HISTORIC AND DESIGN REVIEW COMMISSION

Agenda Item No: 8

HDRC CASE NO: 2015-343
ADDRESS: 268 W MARIPOSA
LEGAL DESCRIPTION: NCB 9013 BLK 7 LOT 11 12 AND 13
ZONING: R4 H
CITY COUNCIL DIST.: 1
DISTRICT: Olmos Park Terrace Historic District
APPLICANT: Jose Cueva
OWNER: Janet Vasquez
TYPE OF WORK: Demo and New Construction
REQUEST:

EXISTING & PROPOSED SITE PLAN

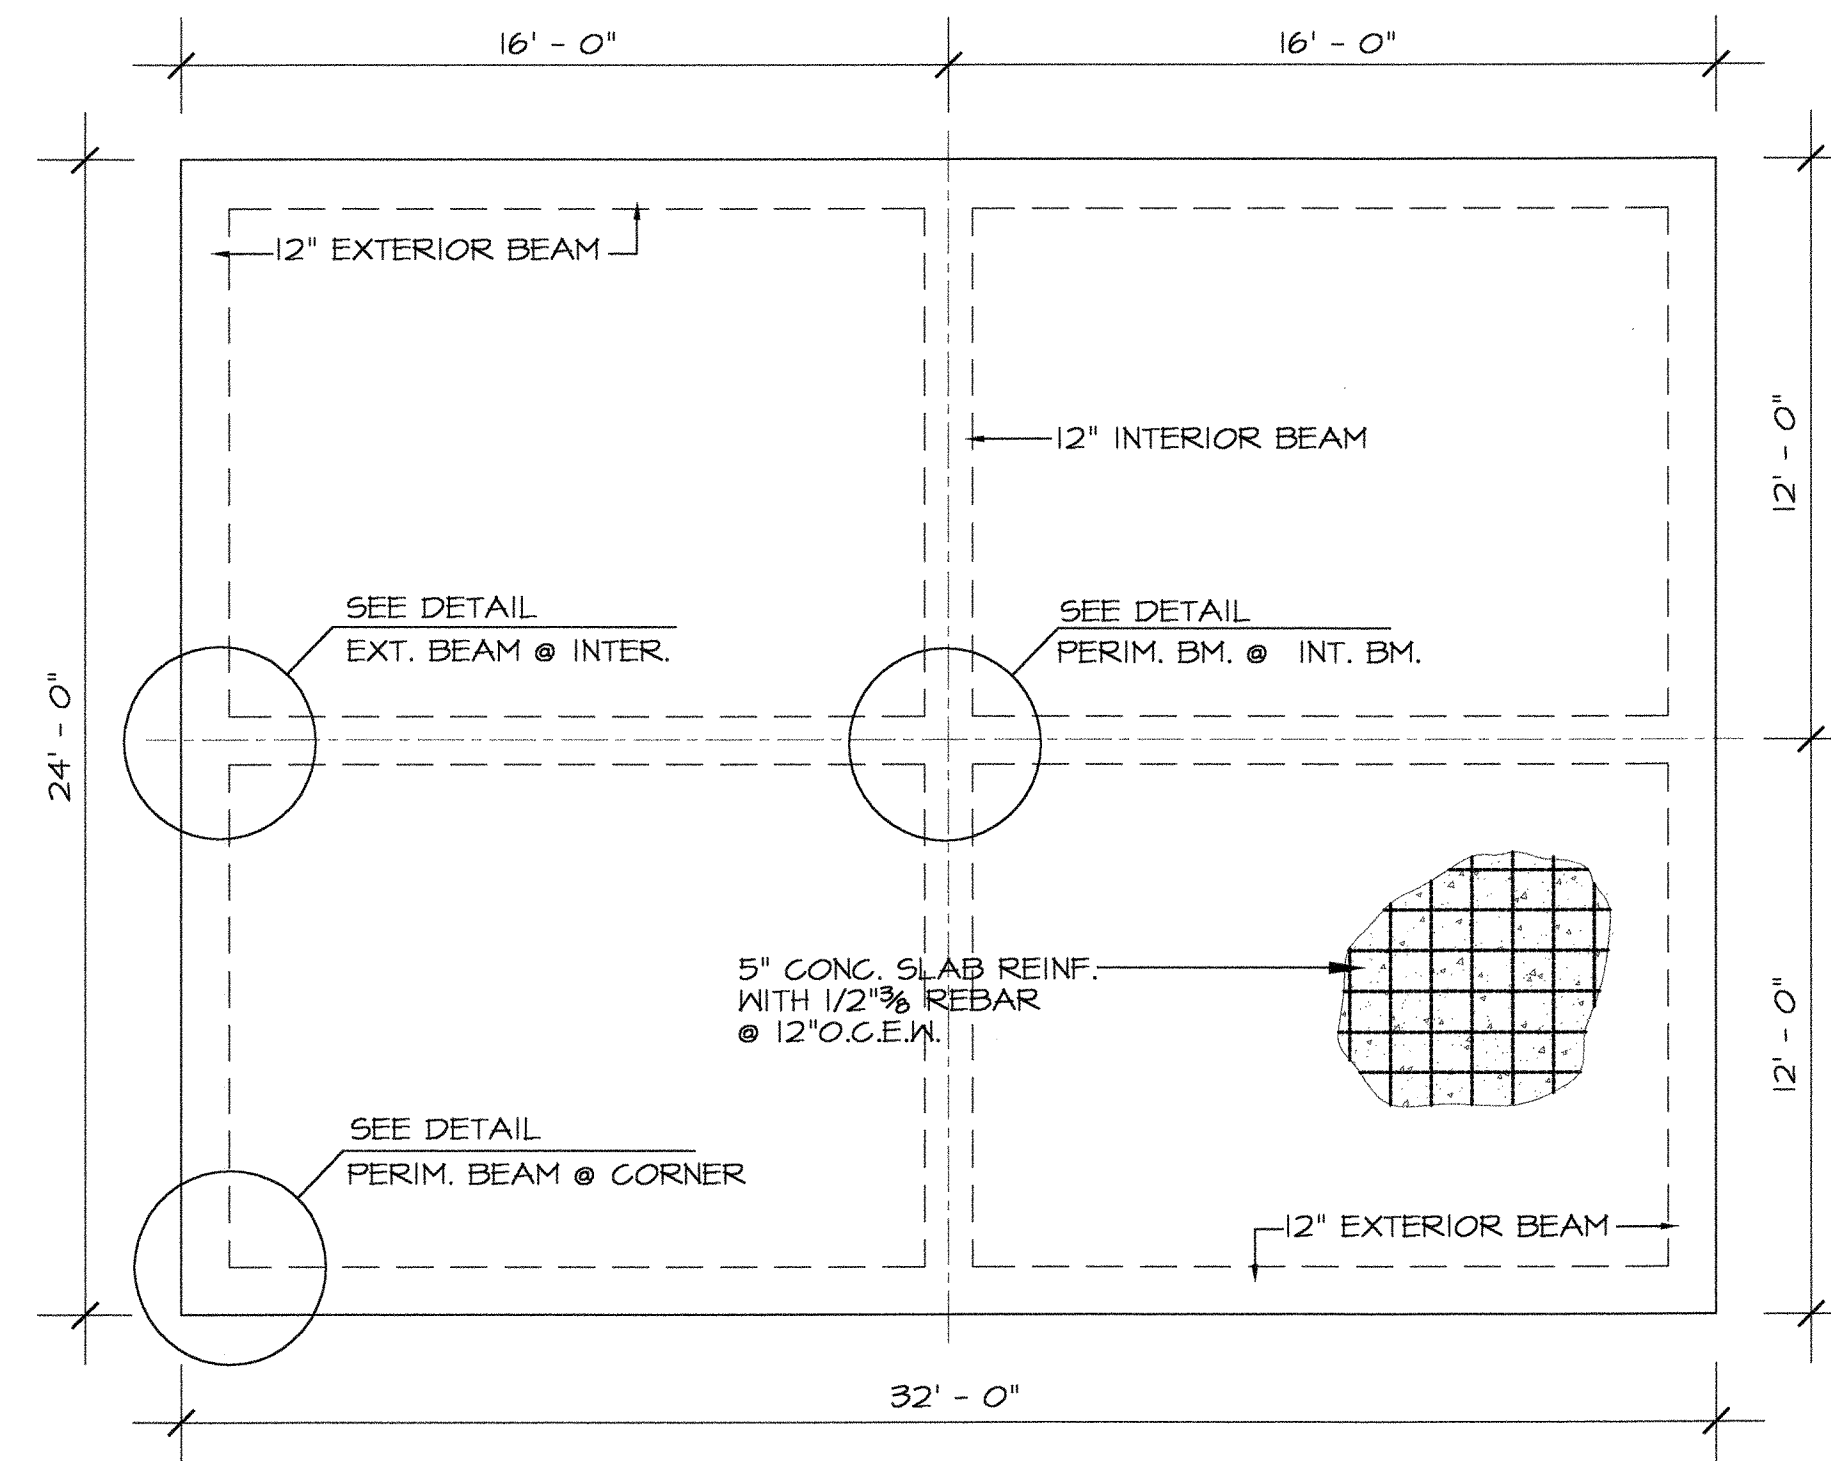
- h. According to the Guidelines for New Construction, historic setback patterns should be followed for new outbuildings. The proposed cottage follows the side setback on the existing structure and expands the rear wall to follow the rear zoning setback. The proposed setbacks are consistent with the guidelines.

EXTERIOR ELEVATIONS

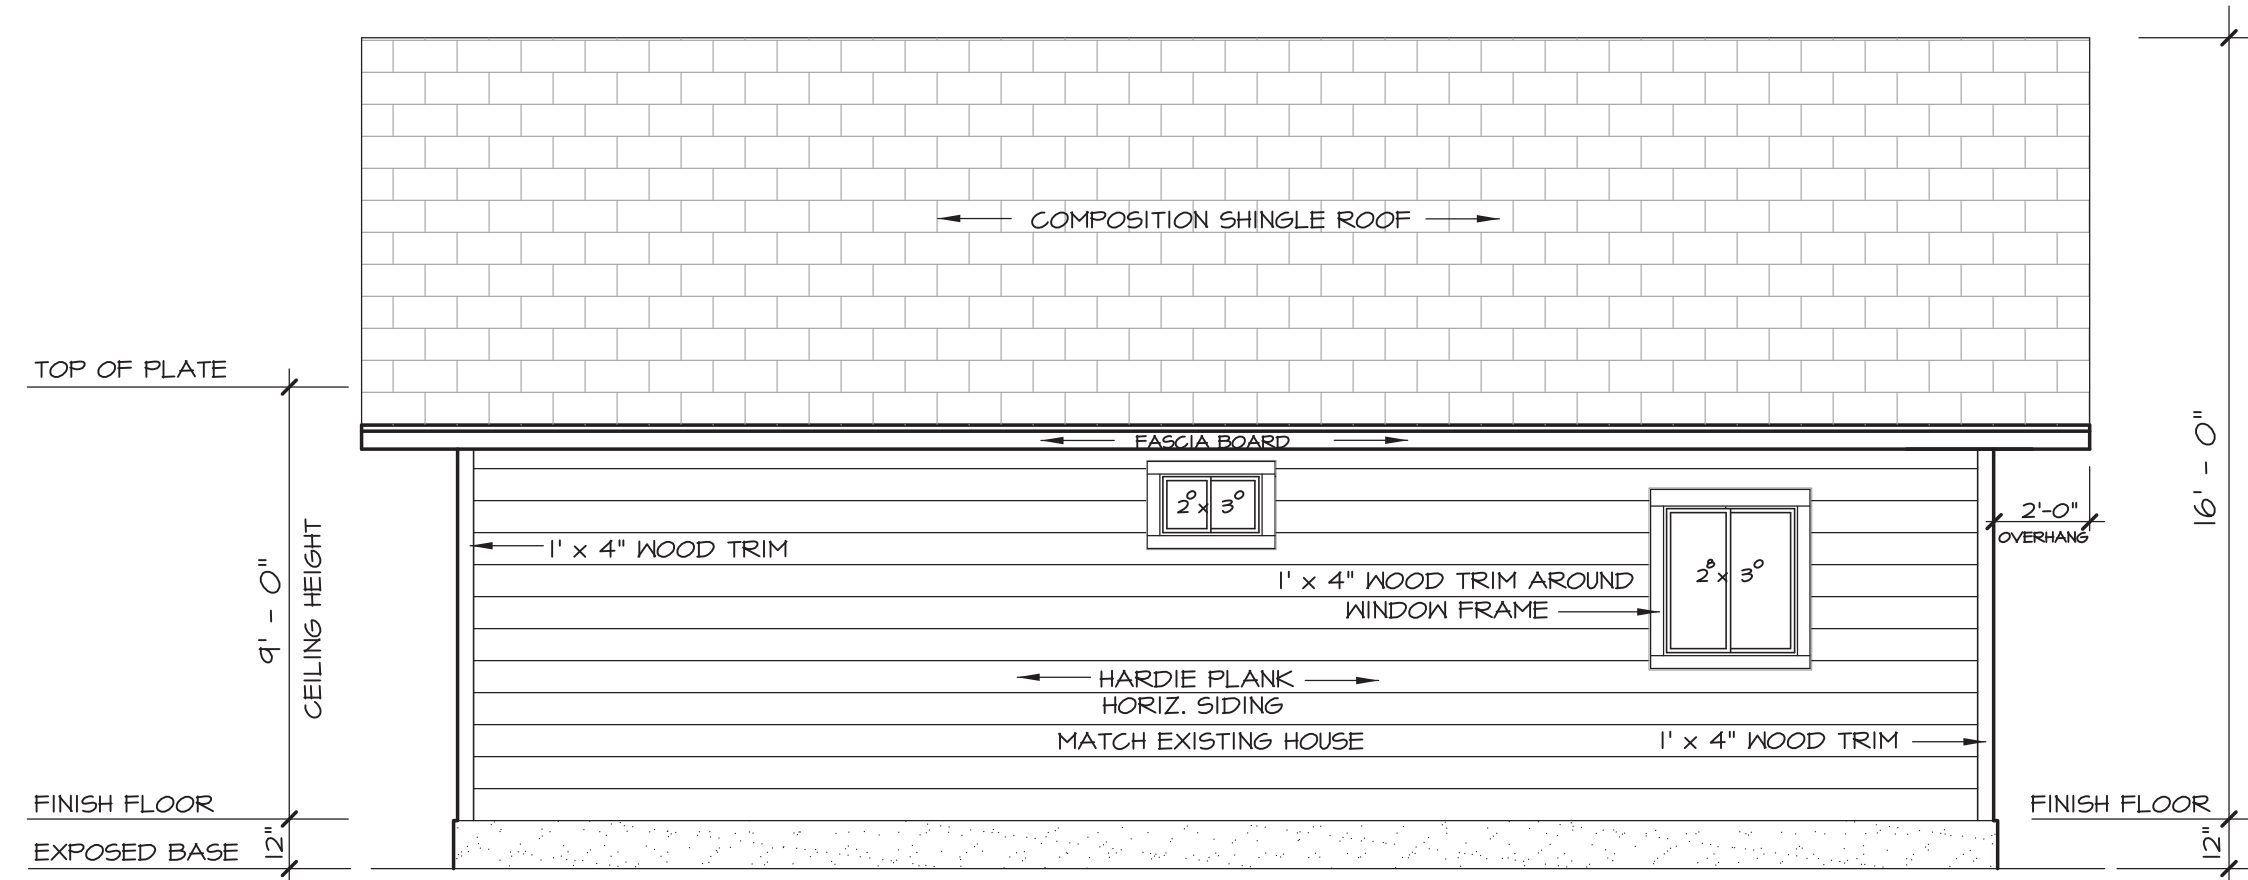
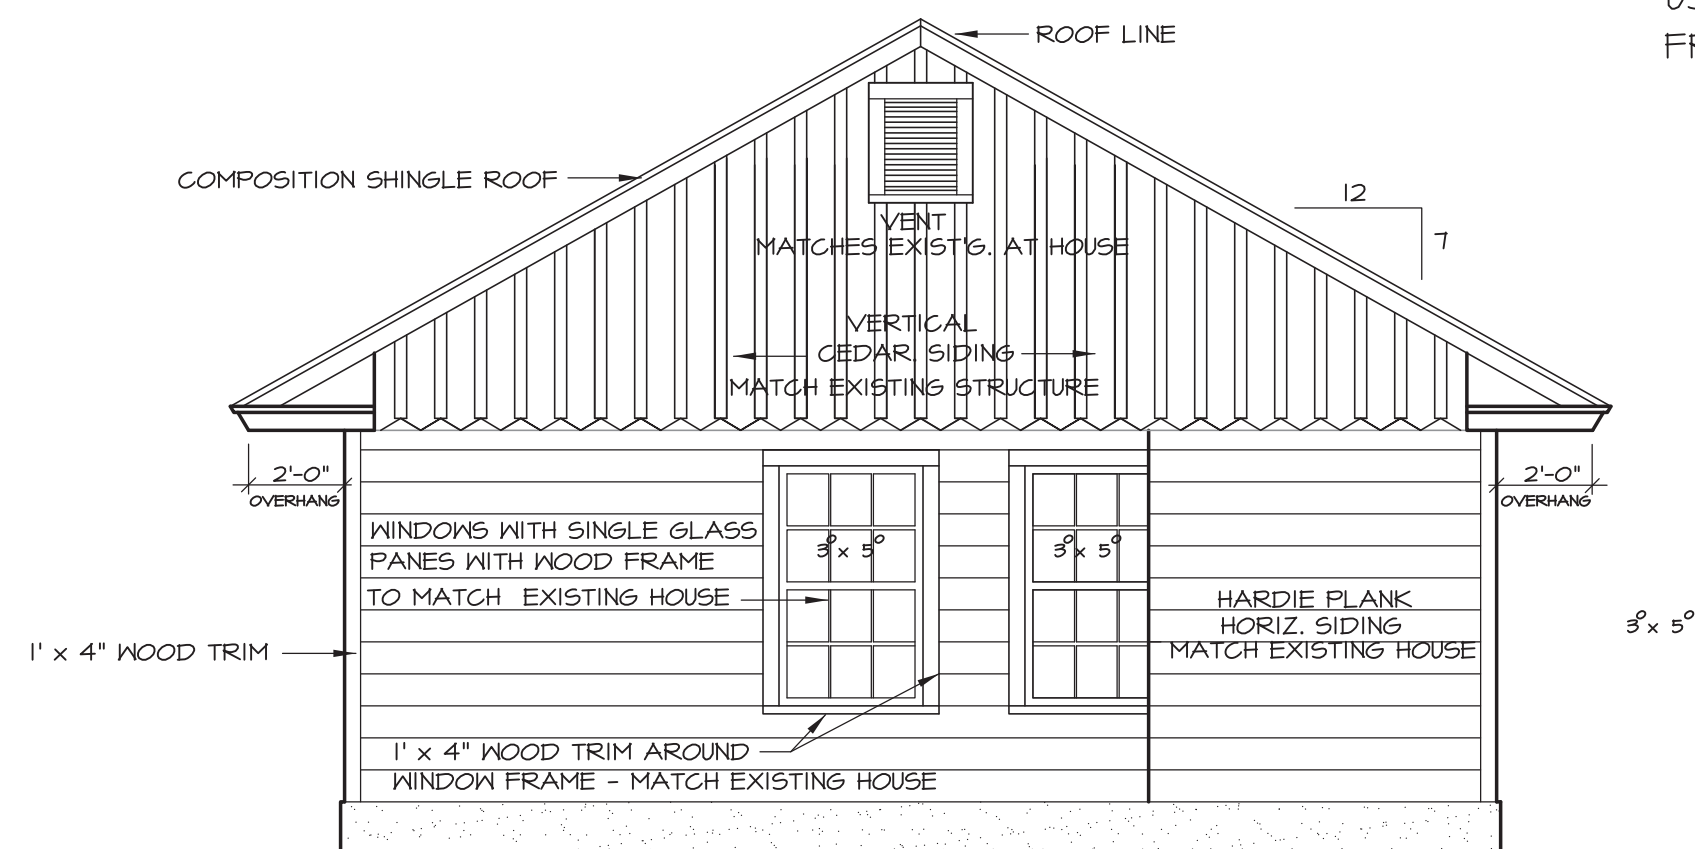
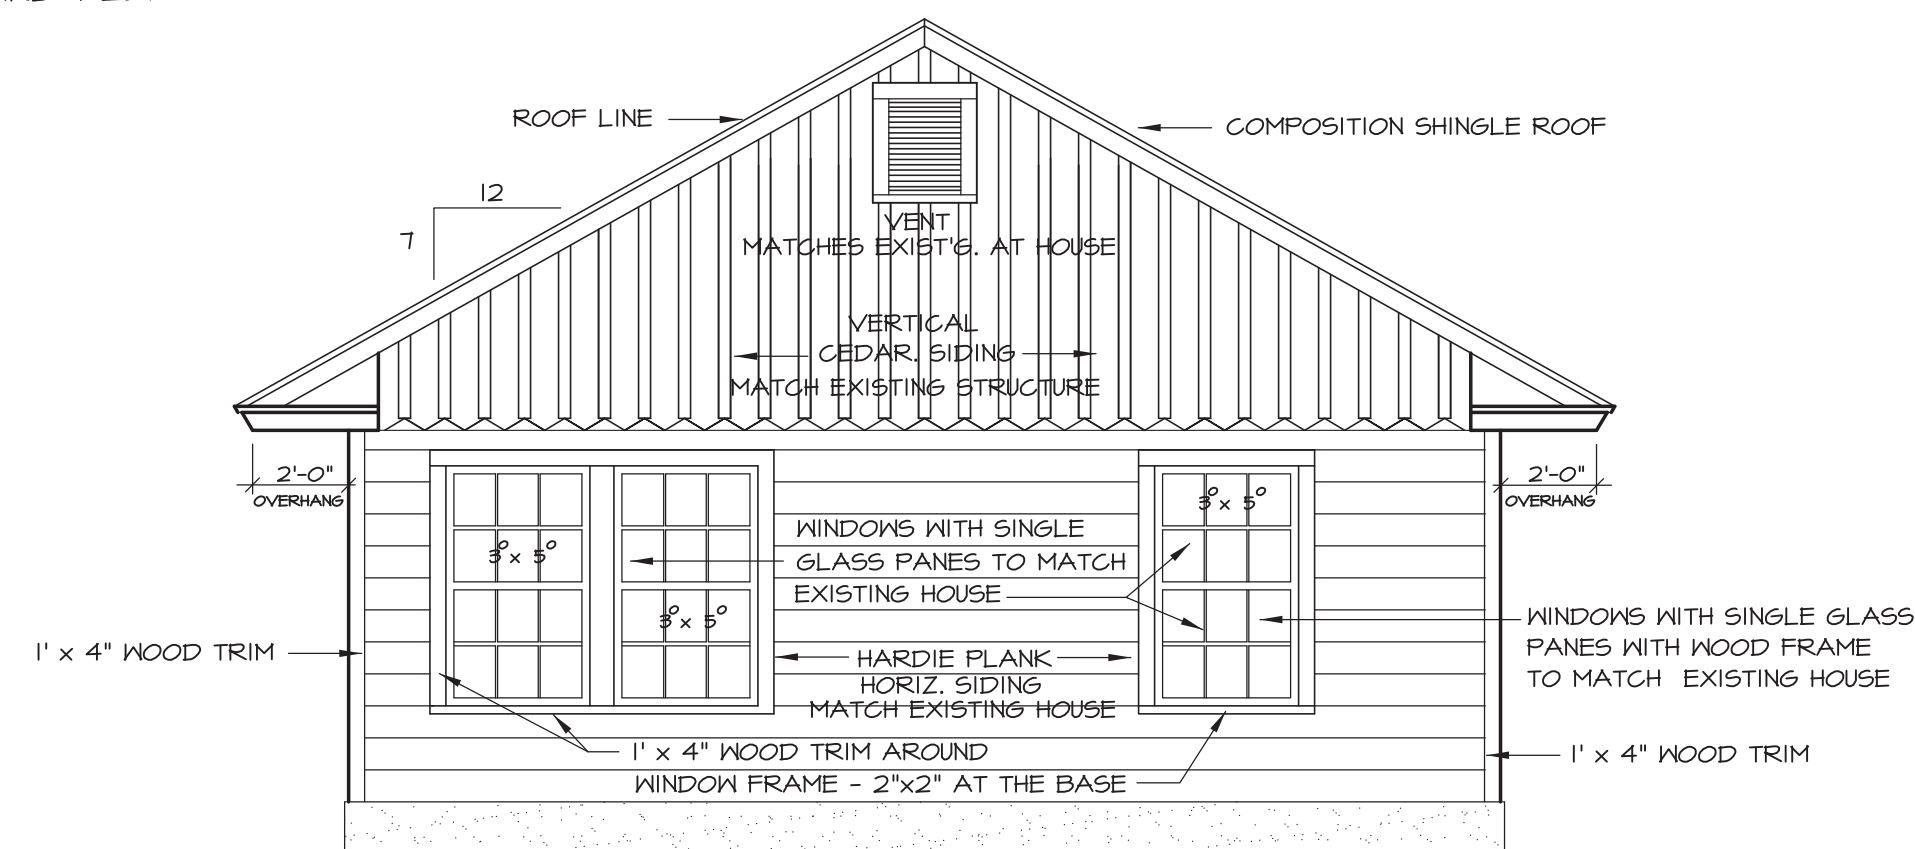
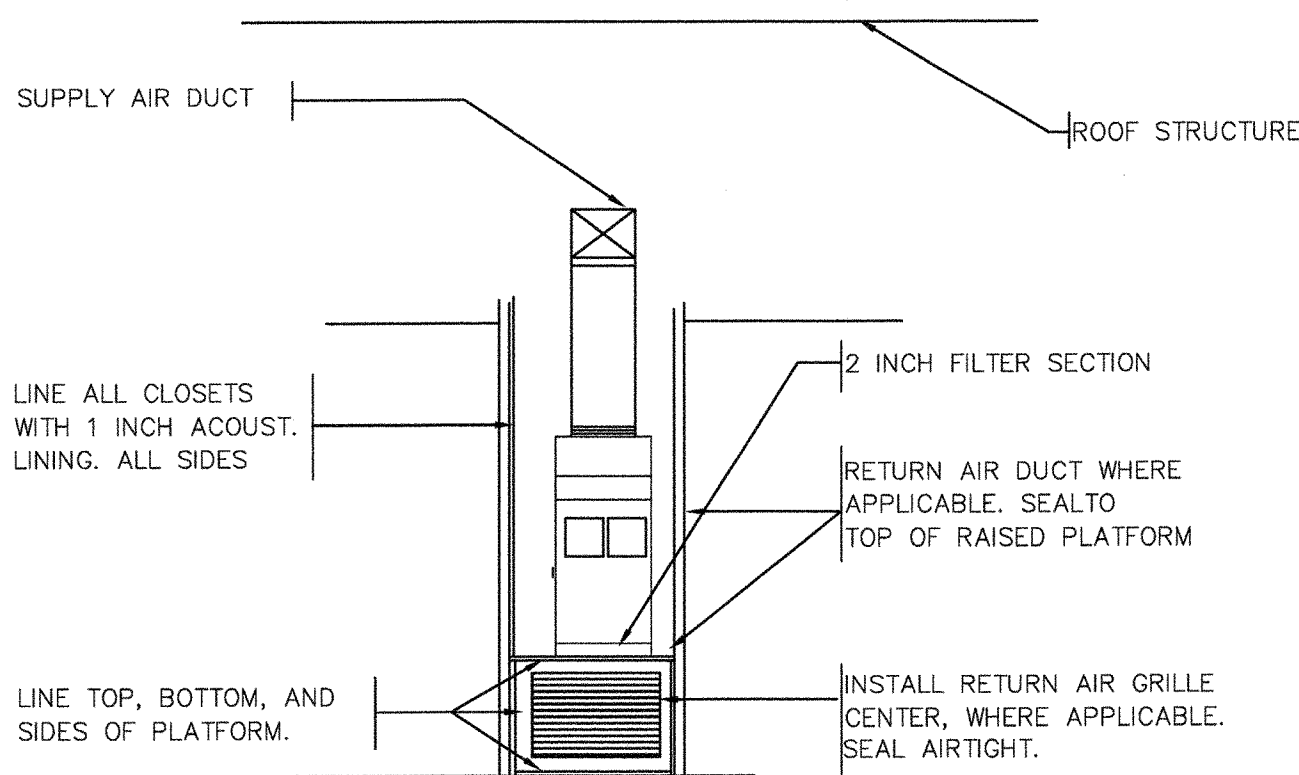
- i. The applicant has provided staff revised design plans showing proposed cottage with six over six true divided windows and new front doors. Cottage windows and doors feature spacing and proportions matching with main house. The new design satisfies earlier staff stipulation that proposed cottage windows and doors be consistent with the main structure in terms of spacing and proportions.

- j. Vertical cedar siding will be added to the front of the gables. This will match the existing structure and would be an appropriate design detail. The applicant has proposed that all salvageable material saved from the dismantling of the existing garage will be used in the new construction.
